Re: BH Storage Stuart- Major Revised Final Site Plan
Project Number: S181-006
Our Ref. #17-425

Please accept this correspondence as our formal resubmittal in response to the staff comments dated February 16, 2018. Please find enclosed the original resubmittal packet containing the revised documents and plans referenced below, a CD with PDF copies of the resubmitted materials, and an additional copy of the 24 x 36 plans. The enclosed revised materials are listed as follows:

**BOUNDARY SURVEY
FOR
EXTRA SPACE STORAGE
MARTIN COUNTY, FLORIDA**

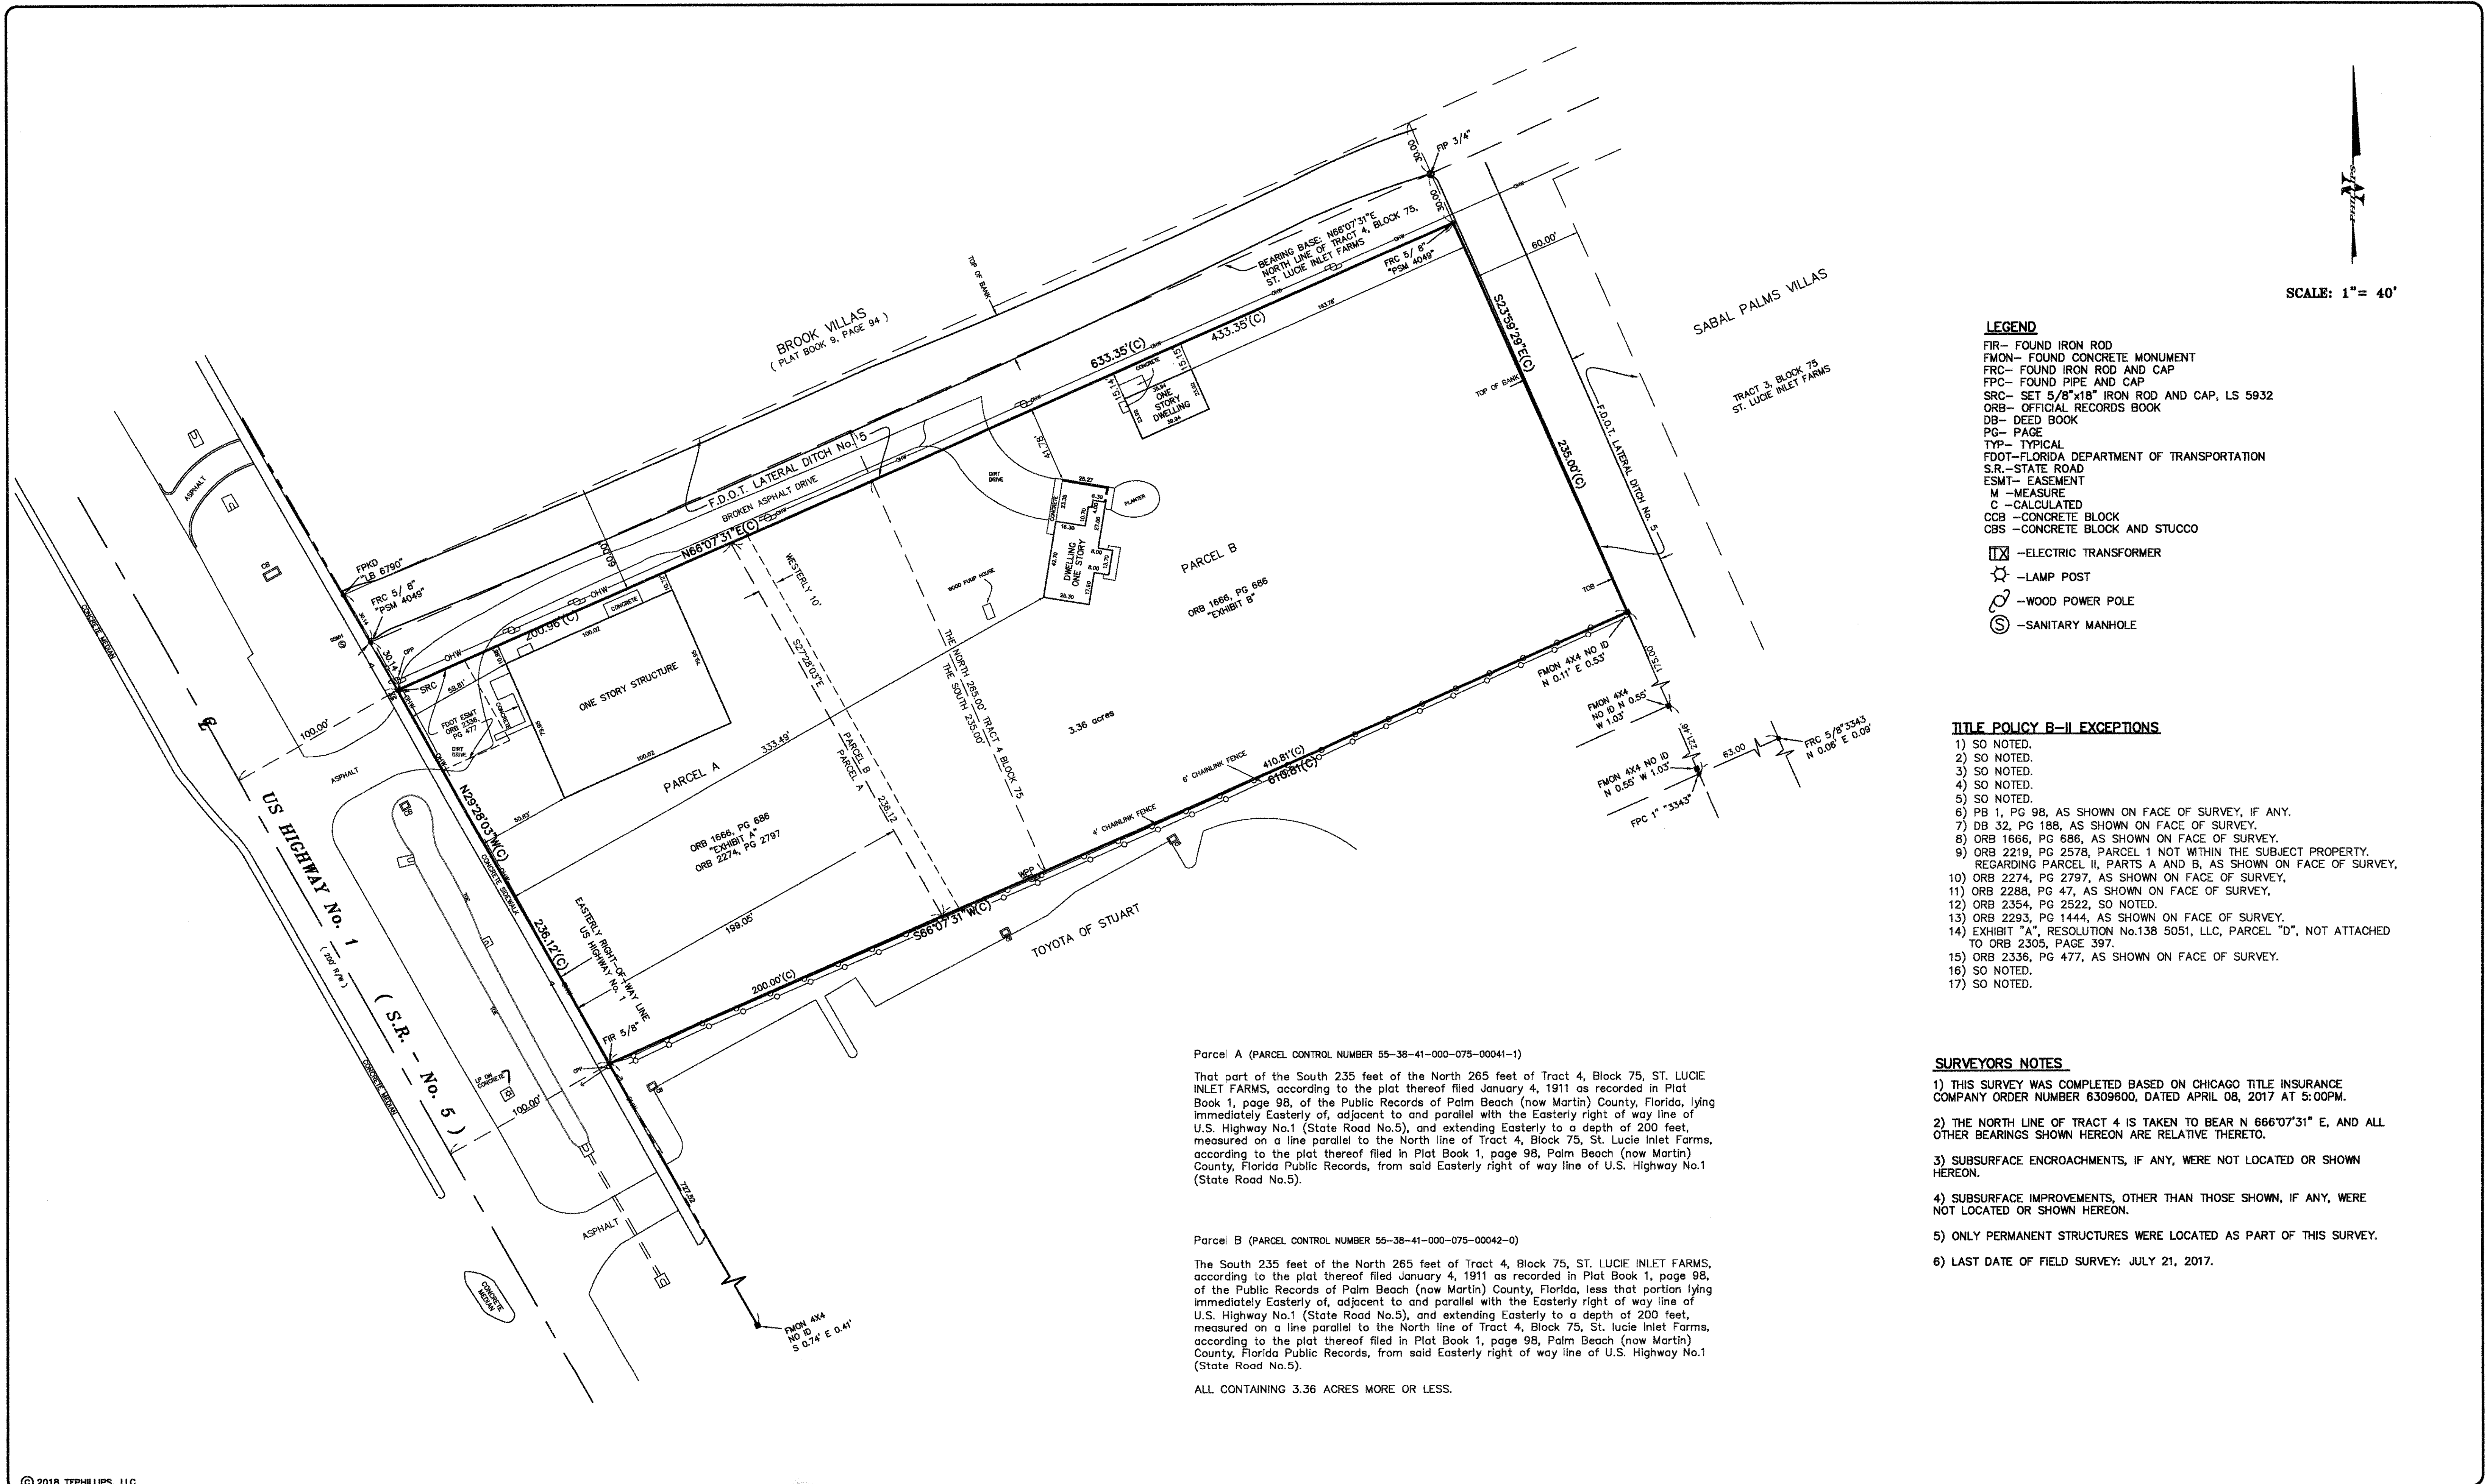
Please include the Parcel Control Number(s) of the subject site on all surveys.

The parcel control numbers have been provided on the surveys.

DATE	BY	REVISIONS
5/18/18	TP	ADD PARCEL CONTROL NUMBERS
